BHARAT HEAVY ELECTRICALS LIMITED
PROJECT ENGINEERING MANAGEMENT, NOIDA

CORRIGENDUM- 06

PROJECT	:	5X800 MW YADADRI TPS
PACKAGE	:	CONDENSATE POLISHING UNIT
ENQUIRY NO	:	E-6389/2019 Dated. 24.02.2020
SUBJECT	:	PRE- BID CLARIFICATION & TECH AMENDMENT# 1

**AMENDMENT TO TECHNICAL SPECIFICATION FOR
CONDENSATE POLISING UNIT 5X800 MW YADADRI
THERMAL POWER STATION**

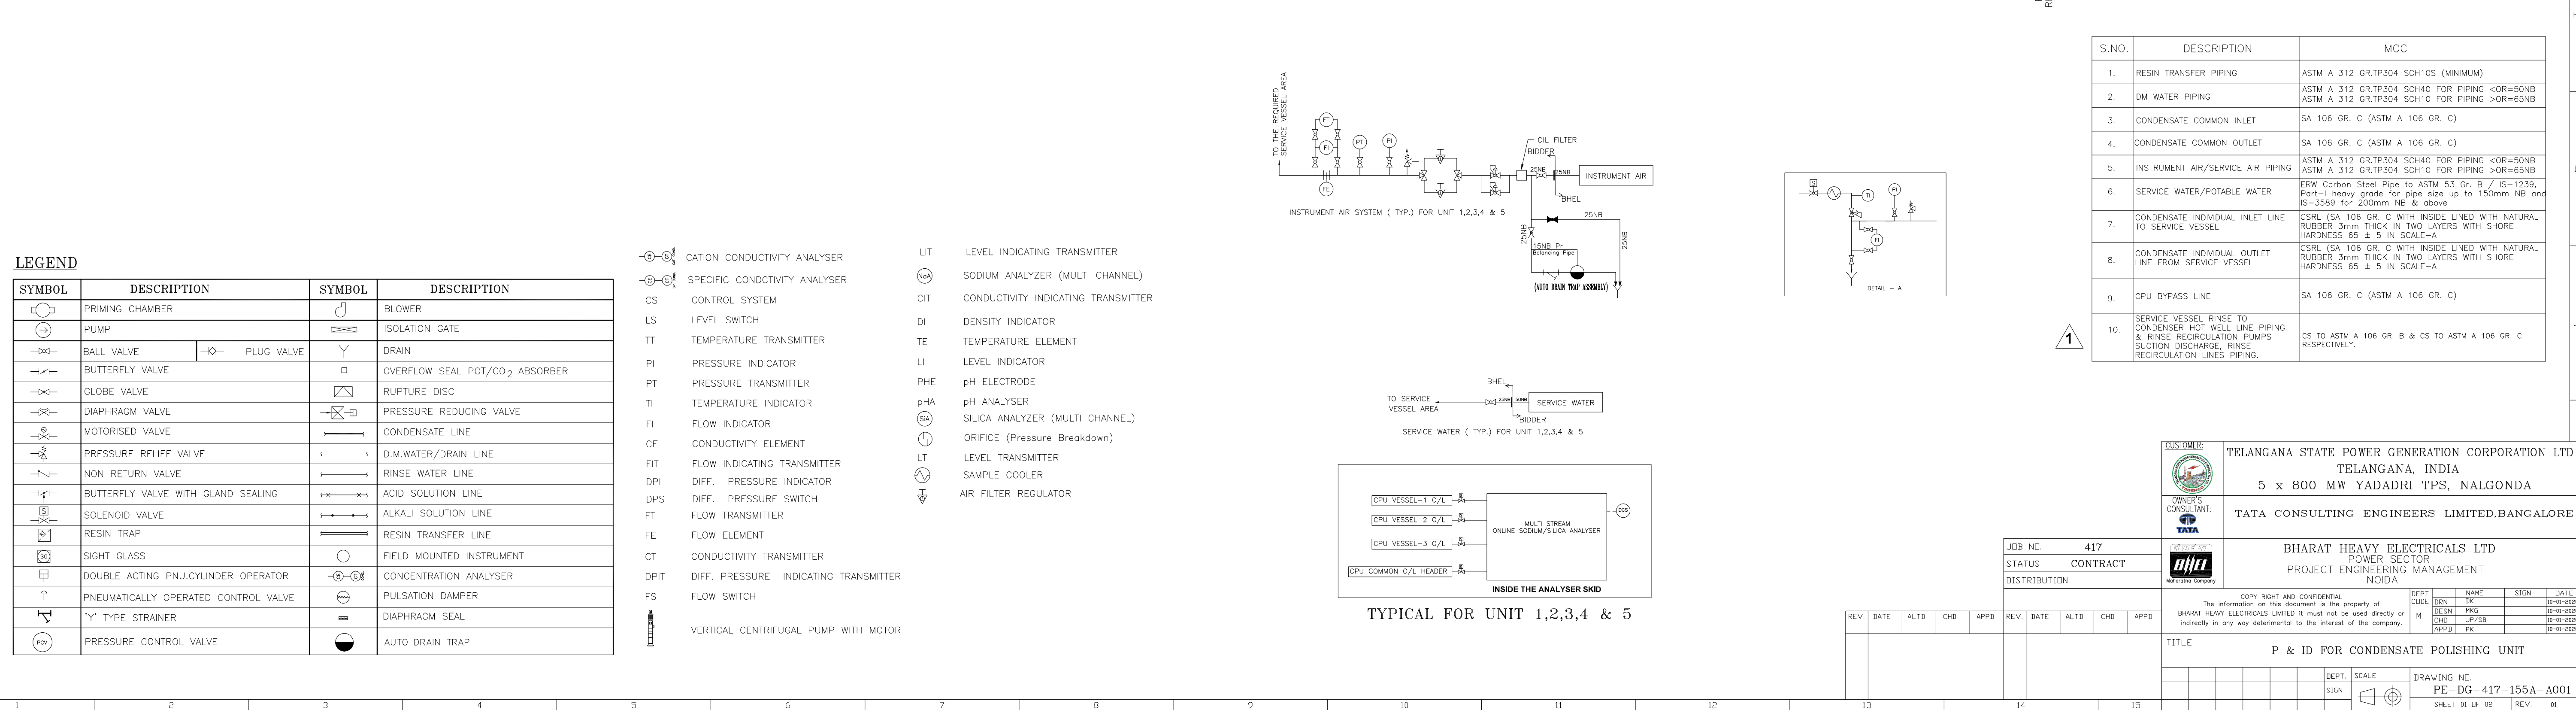
11.	I	Sub-Section– I- A/ P & ID	-	252 to 253 of 663	P&ID OF CONDENSATE POLISHING UNIT	Revised P&ID OF CONDENSATE POLISHING UNIT (2sheets) is attached herewith this amendment for bidder's adherence.

6.	I	Sub-Section– IA, P&ID OF CPU, SHEET 1 OF 2	NOTE NO. 34	252 OF 663	Motor operated valve instead of pneumatic isolation valve shall be provided for each CPU to DM water line. If the same is not indicated all places in this P&ID, bidder to consider the same in their scope wherever applicable.	Referred note stands deleted.

Bidder to adhere the same.
8.	I	Sub-Section– IA,P&ID OF CPU, SHEET 1 OF 2	Piping MOC table sr. no. 10	252 OF 663	RINSE TO CONDENSER HOT WELL AND RINSE RECIRCULATION PUMP SUCTION AND DISCHARGE PIPING-SA 106 GR. B	Service vessel Rinse to condenser Hot well line piping & Rinse recirculation pumps suction, discharge, rinse recirculation lines piping MOC - CS to ASTM A 106 Gr. B & CS to ASTM A 106 Gr. C respectively. Bidder to adhere the same.
